ADDENDUM NUMBER: TWO (2)

TITLE: 11412205281 (RFP) Point Meadows 230-26kV T2 Addition

**Instructions for Contractors and Delivery Personnel at
Commonwealth Service Center**

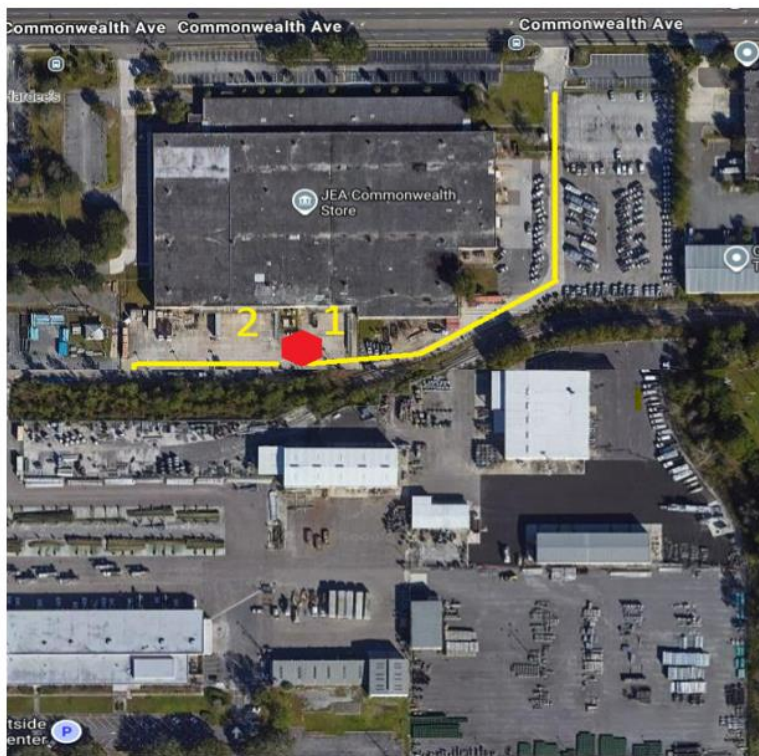
- 18. Question:** Please confirm the location of the JEA storeroom from which Owner-furnished material is to be collected, whether JEA imposes any restrictions on collection scheduling or lot sizes, and whether the Contractor is responsible for offsite storage of Owner-furnished material prior to installation.

Answer: See photo and instructions below.

- Enter through the **Commonwealth Avenue Gate**
- Proceed to the rear of the building, as mark with the yellow lines
- Stop at the **designated red marker** on the map.
- Follow the instructions below for **Pickup and/or Deliveries**.

2. Contractor Pickup Instructions:

- All contractors must enter through the building labeled **#1** on the map and check in upon arrival.
- Pickup hours are **Monday–Thursday, 8:00 AM – 2:30 PM**
- **No pickups are permitted between 11:00 AM – 12:15 PM** due to lunch.
